CITY OF PUNTA GORDA ADA TRANSITION PLAN FINAL REPORT Herald Court Centre

October 4, 2017

Prepared For:
City of Punta Gorda
326 West Marion Avenue
Punta Gorda, Florida, 33950

Figure 4-1 – 2nd Floor Parking Area

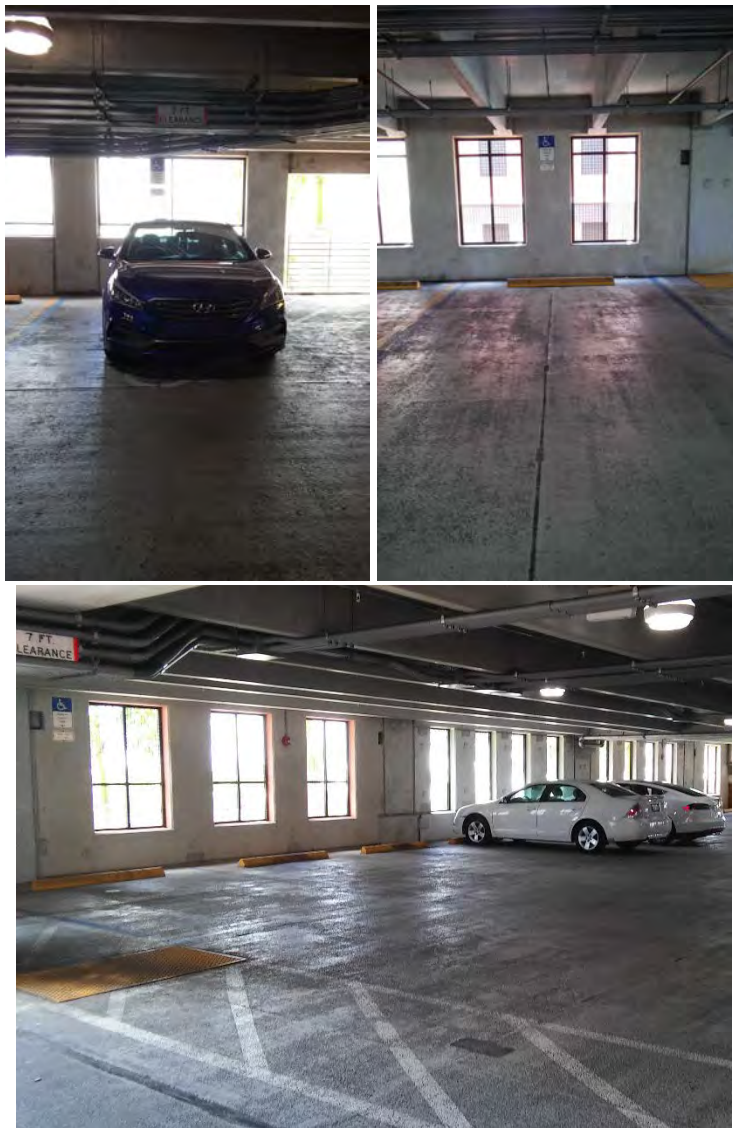
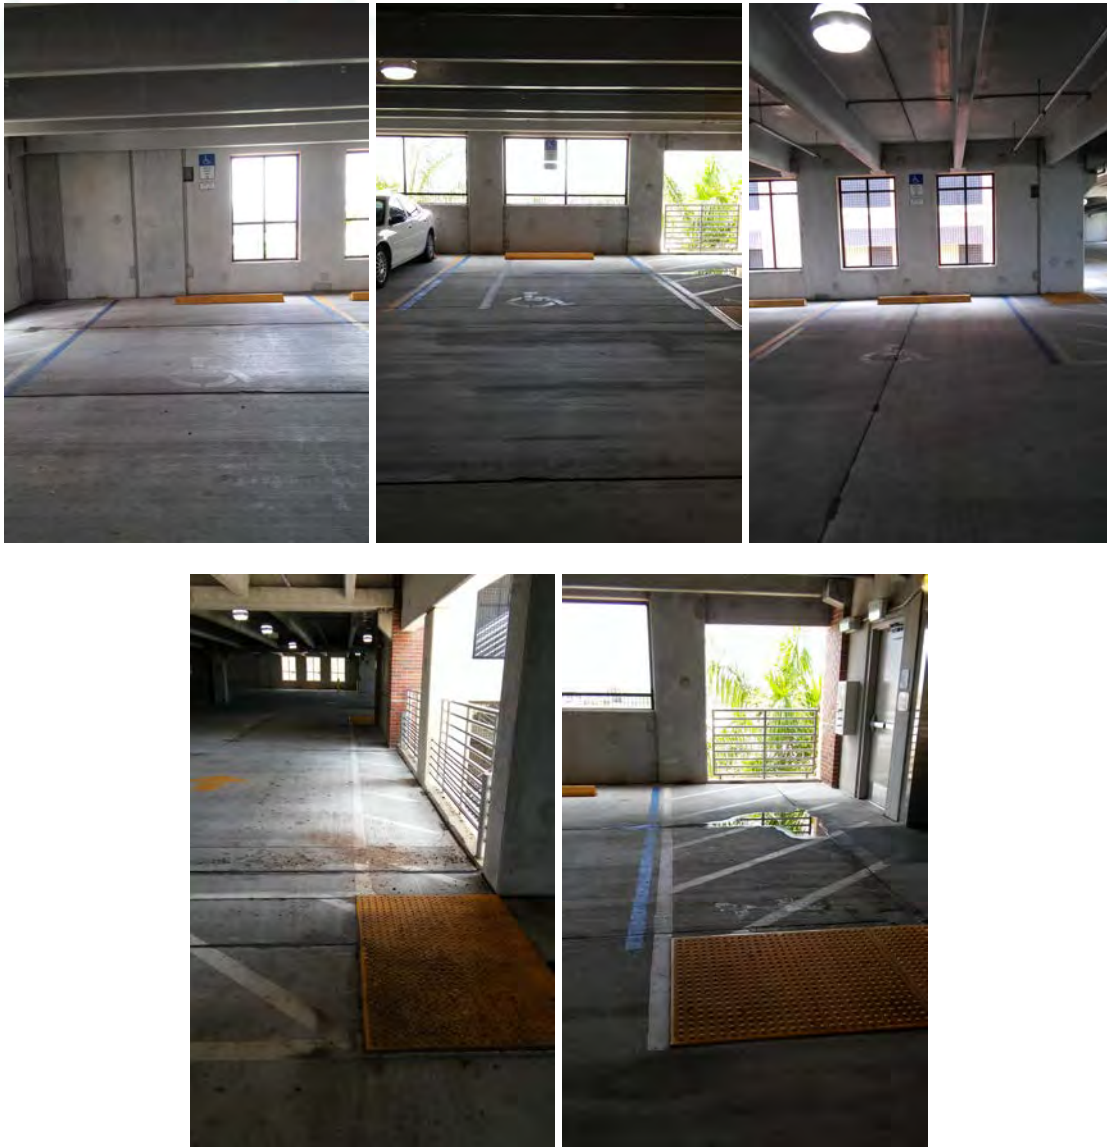
- The striping and ISA symbols are fading.
- The width of the accessible parking spaces are less than 144" wide, violating **FAC 502.2**.
- The access aisles have detectable warning unnecessarily placed on them.
- The width of the marked accessible route narrows to 30" for 36" in length.

- Restripe and repaint the faded parking spaces and ISA symbols.
- The width of the accessible parking spaces must be 144 minimum, per **FAC 502.2**. The adjacent access aisle must be 60” minimum, per **FAC 502.3.1**.
 - Note, **ADAAG 502.1** states that “Where parking spaces or access aisles are not adjacent to another parking space or access aisle, measurements shall be permitted to include the full width of the line defining the parking space or access aisle.”
- Remove all detectable warning from the access aisles and accessible route within the parking garage.
- Although the width of the marked accessible route narrows to 30" for 36" in length, a portion of the vehicular traffic lane can be utilized. Widening the marked accessible route, while not required, would provide additional safety benefits, per **FAC 502.3**.

Figure 4-6 – Protruding Objects

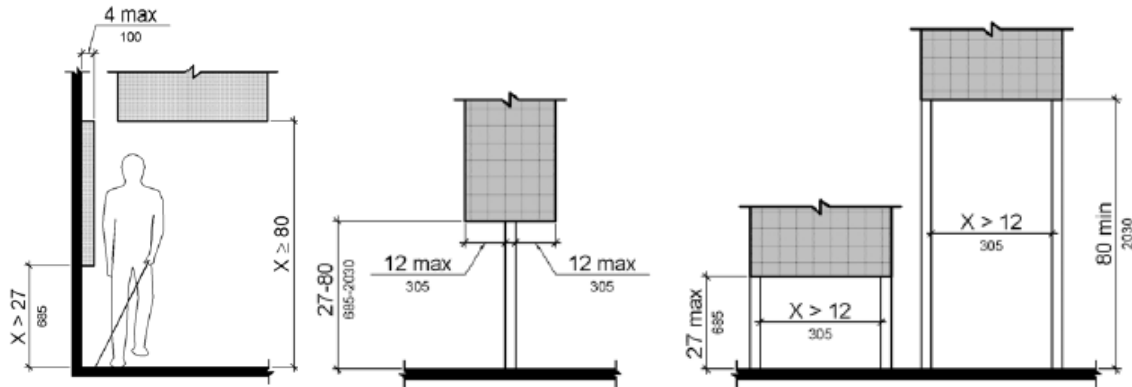
A protruding object, as pictured below, are objects that extend out into the accessible route greater than 4" at a height greater 27 and less than or equal to 80", per **ADAAG 307.1**. In addition, a post-mounted object can overhang the circulation path no greater than 12" at a height of 27" to 80", per **ADAAG 307.3**.

- Recess the water fountains or add a cane apron or fountain skirt under them so they do not protrude into the circulation path per **ADAAG 307.2**.
- Relocate the pathway sign so as to be centered on the pole and therefore not protrude beyond 12" on either side of the pole, per **ADAAG 307.3**. Or, extend the sign so that the bottom of the sign is less than 27" above the ground.
- Either relocate the fire extinguisher so that the bottom edge is less than 27" above the ground per **ADAAG 307.2** or add a pipe or a similar barrier below the fire extinguisher box to make it cane detectable.
- Charlotte County BOCC must either shorten the handrail extension to be no more than 12" in length or add an additional section of handrail, parallel to the existing extension connecting to the vertical section at a height no greater than 27".

Figure 4-7 – Protruding Objects

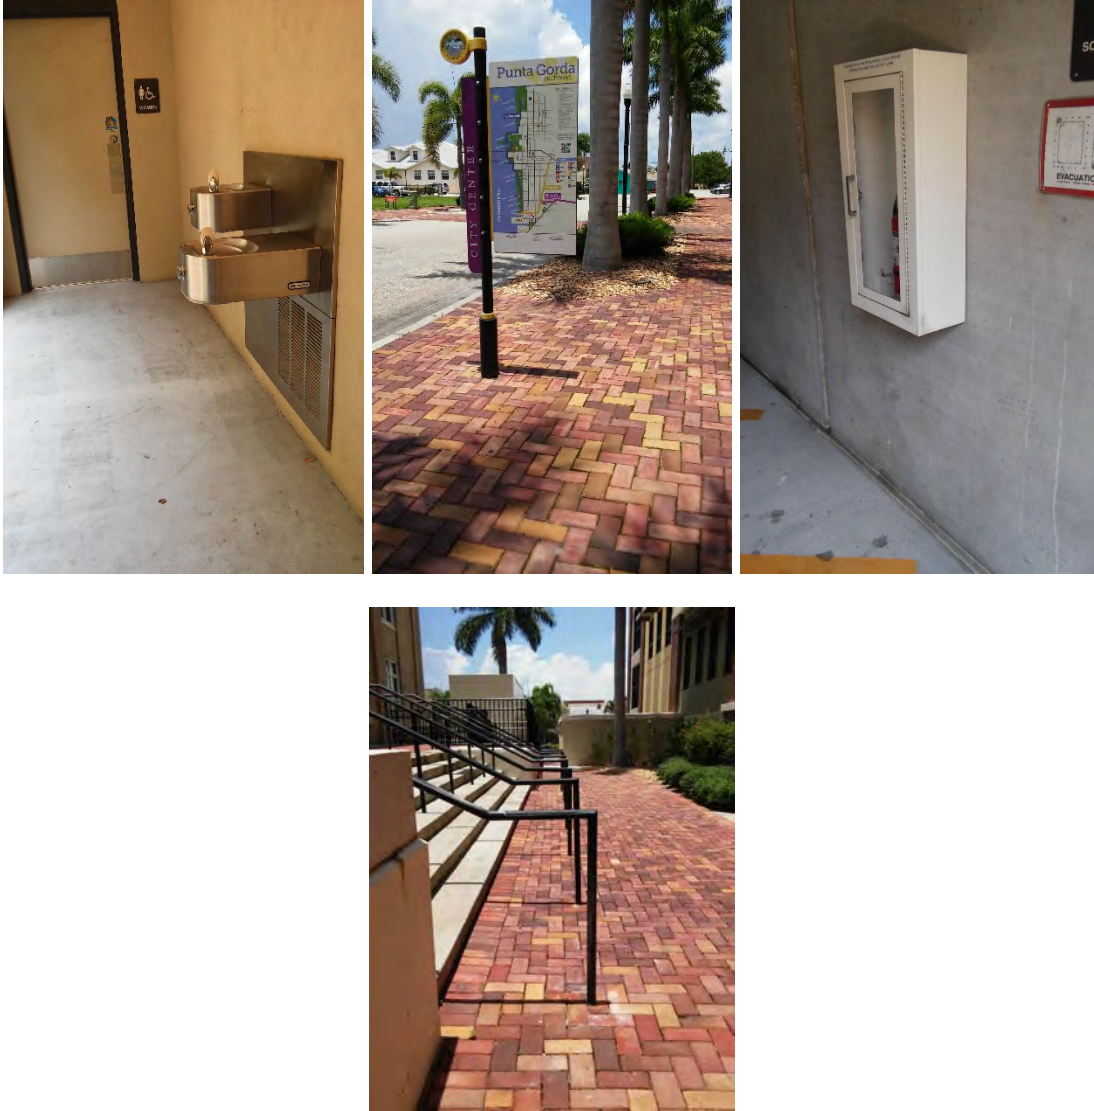
- The low water fountains, adjacent to the restrooms on the first floor protrudes from the wall 17" at a height of 27.5".
- The high water fountains, adjacent to the restrooms on the first floor protrudes from the wall 12" at a height of 34".
- The pathway sign adjacent to the road protrudes out 24" at a height of 35".
- The fire extinguisher, located by the southwest stairwell, protrudes out 7" at a height of 33".
- The handrails leading to the adjacent historic courthouse property, which is owned and maintained by the Charlotte County Board of County Commissioners, protrude out 24" at a height of 36".

Figure 4-8 – Accessible Route

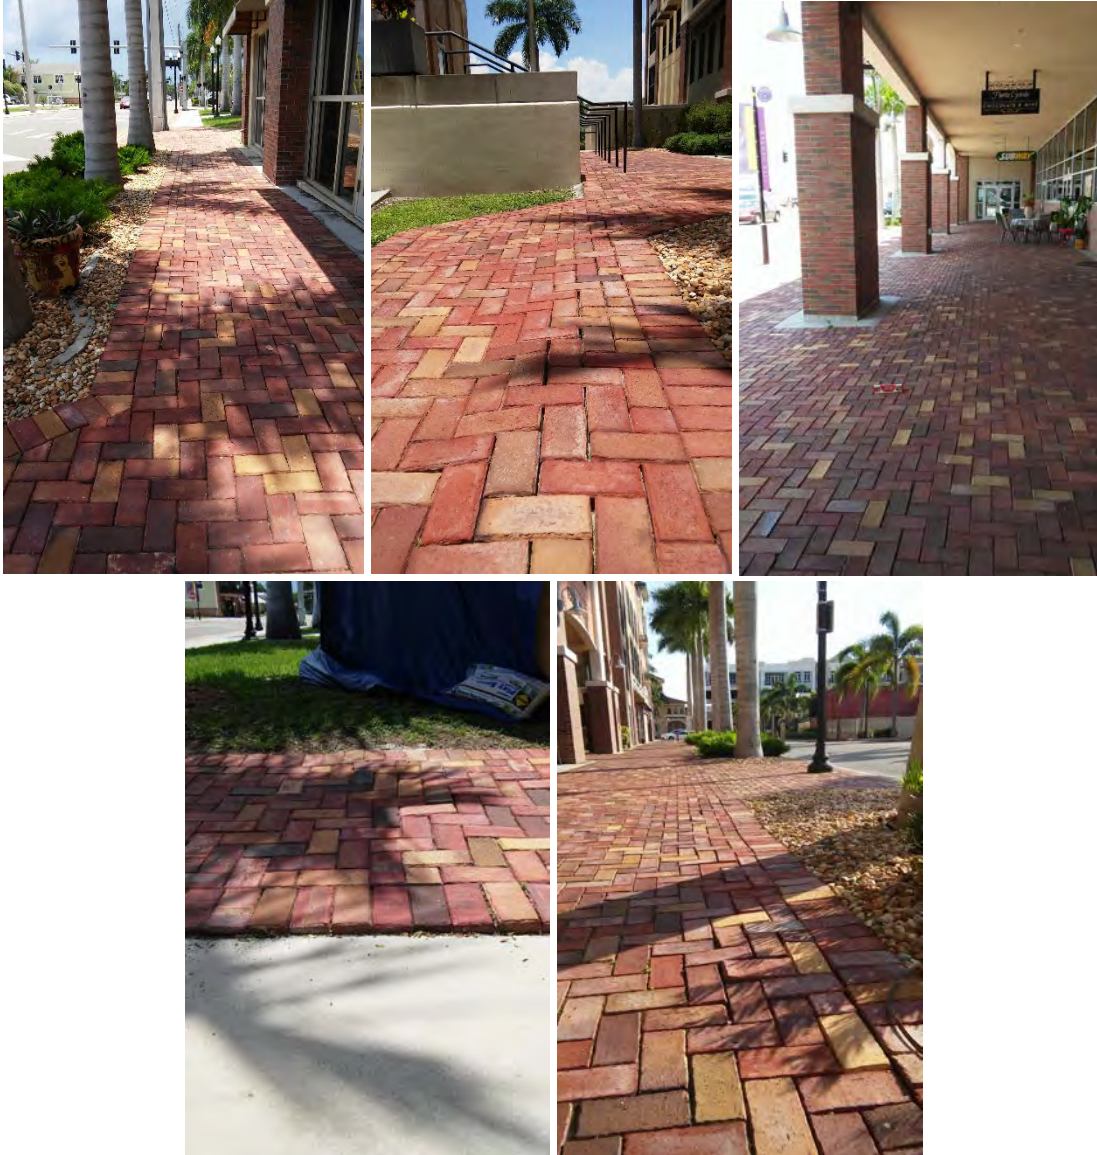
- The brick walkway, shown in the first photo, on the south side of the parking facility, adjacent to the Artisans store has a cross slope of 6%, violating **ADAAG 403.3**.
- The second photo shows the brick path adjacent to the rear of the courthouse, which has a running slope of 6%, violating **ADAAG 403.3**.
- The third photo, on the north-east side of the facility, adjacent to US-41, has an 8% cross slope, violating **ADAAG 403.3**
- The last two photos show two locations where there are tripping hazards due to the bricks not settling in an even and level manner, , violating **ADAAG 303**.

- Resurface the brick walkway around the perimeter of the parking garage to have a running slope no greater than 5% and a cross slope no greater than 2%, per **ADAAG 403.3**.
 - An accessible route is required to be a minimum of 36" wide and have 60" passing spaces every 200', per **ADAAG 403.5.1** and **ADAAG 403.5.3**. While it is not required that the entire width of the walkway be of compliant slope, at its current configuration it is difficult for people to distinguish where it is safe to traverse and where there are barriers to accessibility.
- Resurface any tripping hazards so they are no higher than 0.25" high or 0.5" high if beveled, per **ADAAG 303**.
